Access Compliance Report

Public Rights-of-Way

(Curb Ramps)

Intersection ID: 24035	Main Street: ECHO_FOREST_DR	Cross Street: PINEVILLE-MATTHEWS_RD	Location: S
ADA ID: BD1715DA33AB	Ramp Type: Perp	Initial Pass/Fail: Fail	Overall Compliance: No
			Severity Score: 12.5

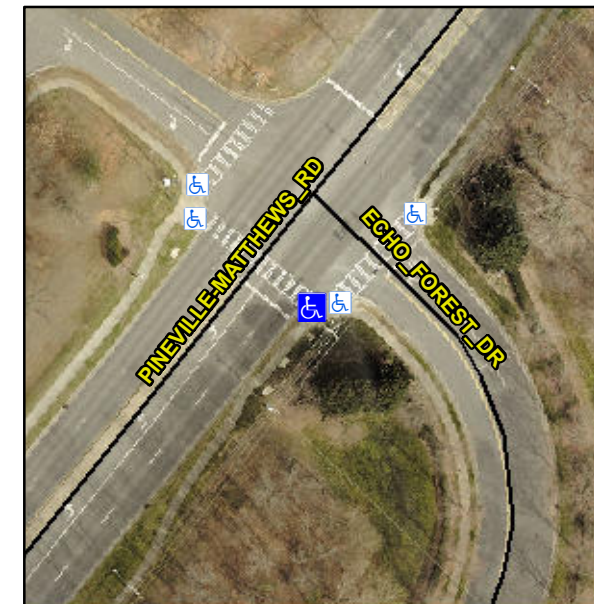
Not Found, R304.2.2

Compliance	Description	Data	Compliance	Description	Data
N/A	Ramp Length (in)	112.0	No	Ramp Slope (%)	8.7
Yes	Ramp Width (in)	48.0	Yes	Ramp XSlope (%)	1.6
N/A	Flare Type LT	N/A	N/A	Flare Type RT	N/A
N/A	Flare Slope LT (%)	N/A	N/A	Flare Slope RT (%)	N/A
N/A	Flare Traversable LT?	N/A	N/A	Flare Traversable RT?	N/A
N/A	Landing Length (in)	N/A	N/A	DWS Provided?	N/A
N/A	Landing Width (in)	N/A	N/A	DWS Contrast?	N/A
N/A	Landing Slope (%)	N/A	N/A	DWS Length (in)	N/A
N/A	Landing X Slope (%)	N/A	N/A	DWS Full Width?	N/A
N/A	Landing Curb? (Y/N)	N/A	N/A	DWS Offset (in)	N/A
N/A	Shared Landing?	N/A			
N/A	Gutter Ponding?	N/A	N/A	Gutter Slope (%)	N/A
N/A	Gutter Lip Ht (in)	N/A	N/A	Gutter X Slope (%)	N/A
N/A	Painted X Walk1?	Yes	N/A	Painted X Walk2?	N/A
	X Walk 1 Direction	To NW		X Walk 2 Direction	N/A
N/A	X Walk 1 Width (in)	108.0	N/A	X Walk 2 Width (in)	N/A
	X Walk 1 Slope (%)	3.3		X Walk 2 Slope (%)	N/A
	X Walk 1 X Slope (%)	2.7		X Walk 2 X Slope (%)	N/A

Remove & Replace Entire Ramp.
